Subject: Catawba Nuclear Station - York County, South Carolina  
Permit#76-2A-084  
Standby Nuclear Service Water Pond Level Increase to Elev. 574  
File: CN-702.11

A review of our files indicates that a permit for the Catawba Nuclear Station was issued on February 22, 1977 (#76-2A-084). Therefore, this office is hereby granting a modification to that permit to reflect the change on the attached drawings (Sheets 1-3 of 3 dated January 25, 1996). This change includes the replacement of an existing 1 foot steel plate located in the discharge headwall with a 3 foot steel or concrete plate.

SECTION A-A

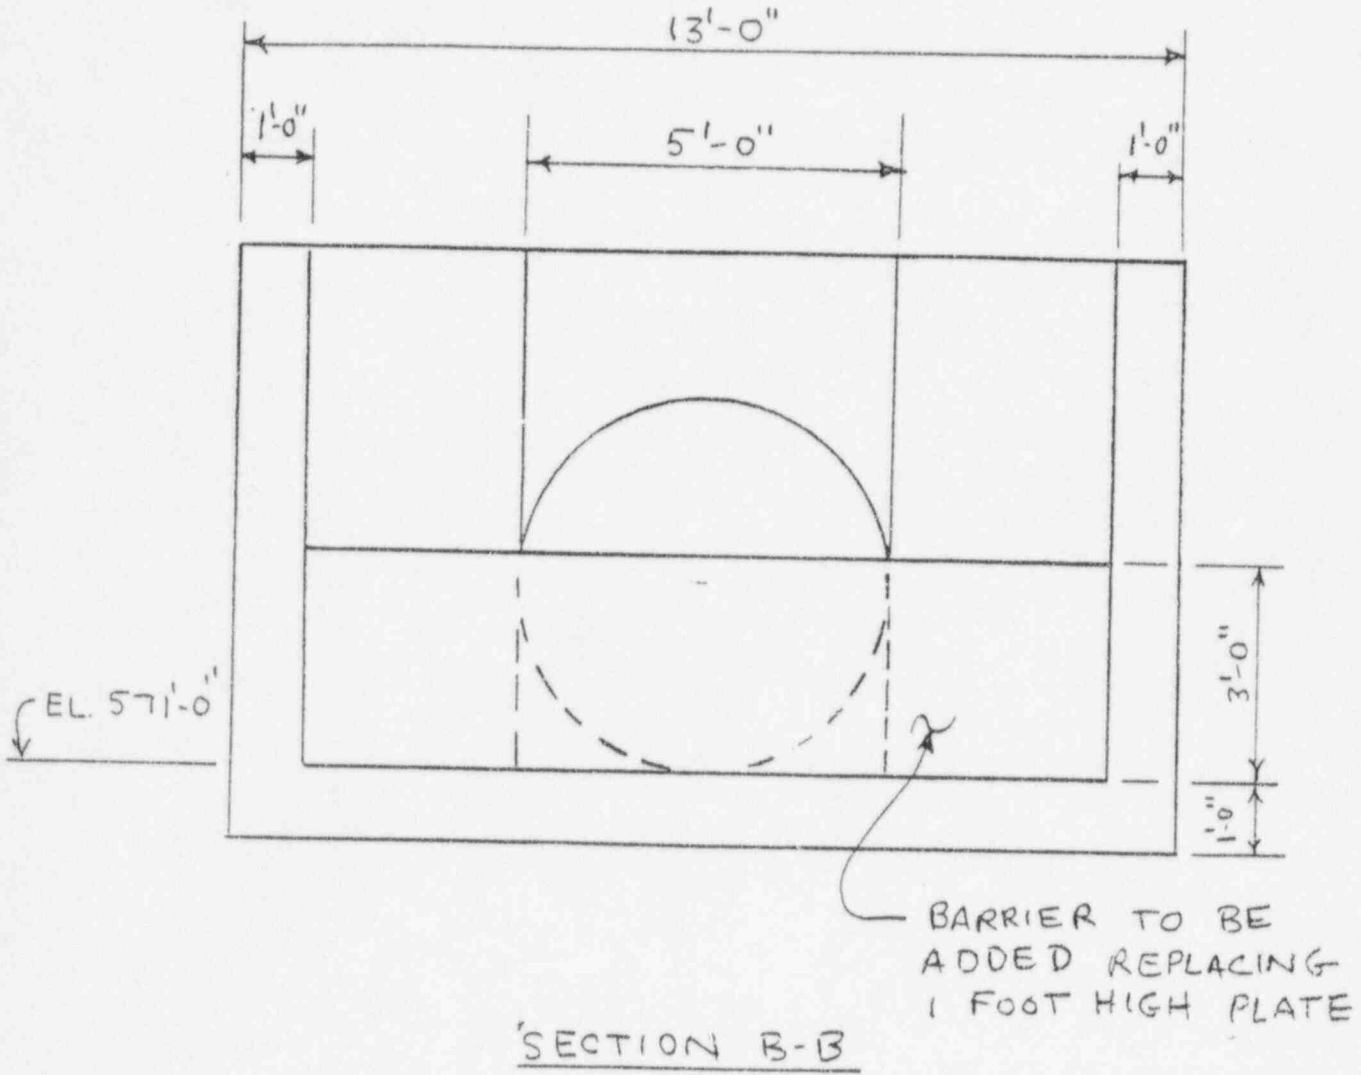
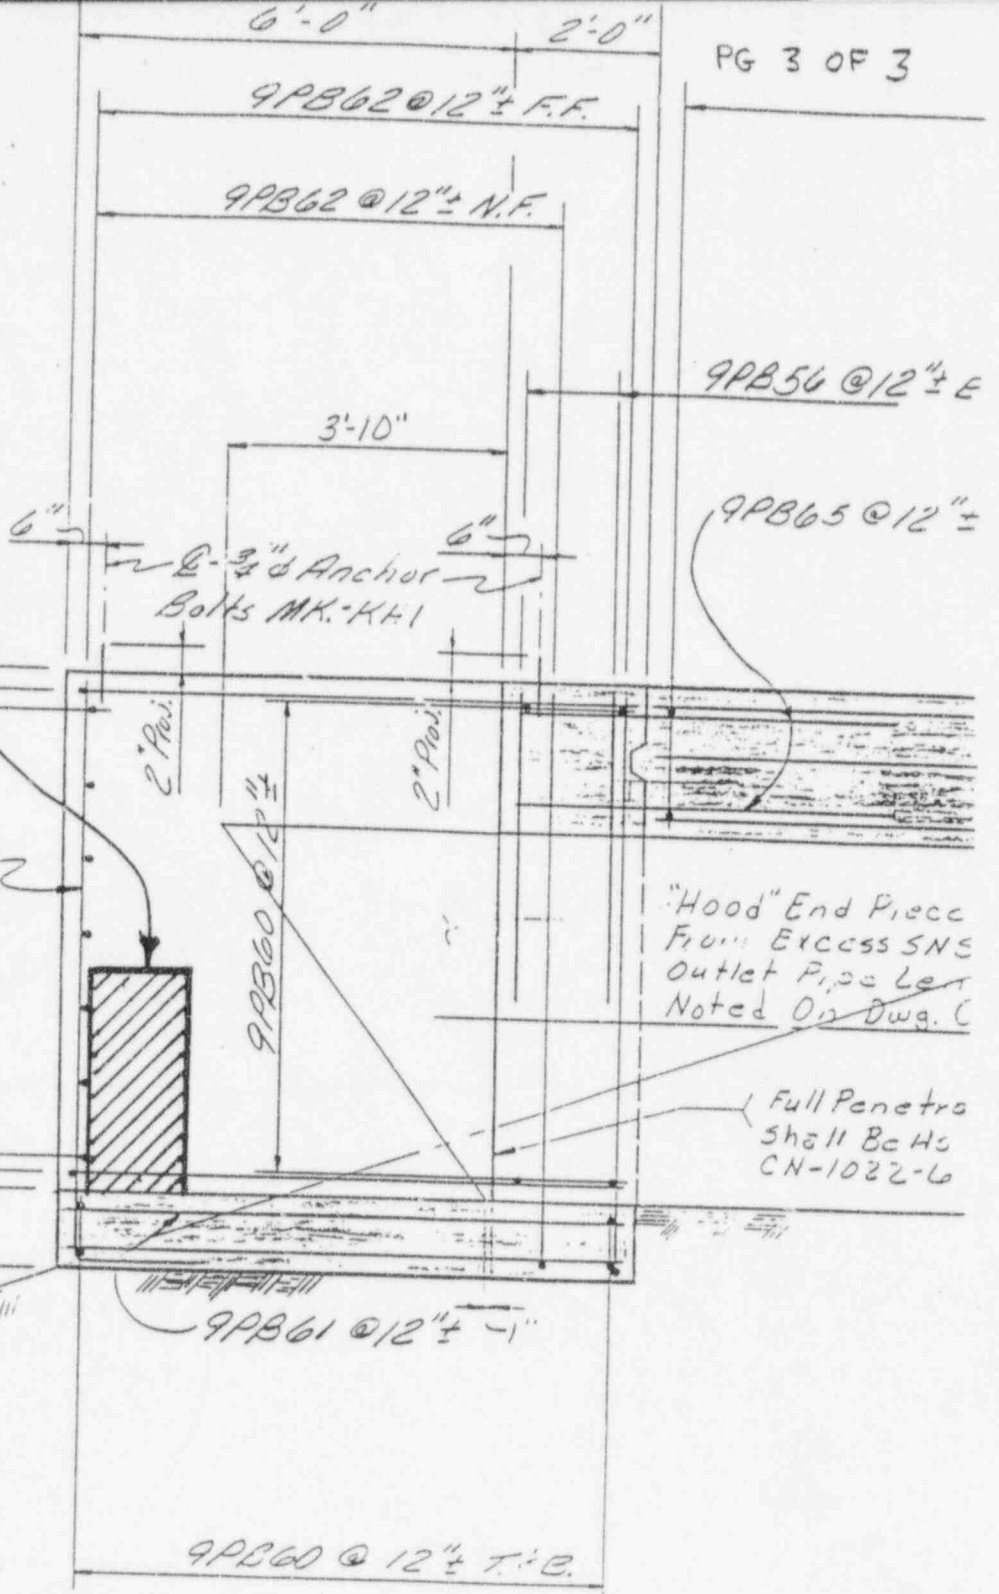
SNSW POND DISCHARGE HEADWALL PROPOSED MODIF.  
REPLACE EXISTING ONE FOOT HIGH PLATE WITH  
3 FOOT HIGH CONCRETE OR STEEL BARRIER

STEEL WELDMENT OR WALL TO BE ADDED (BARRIER)
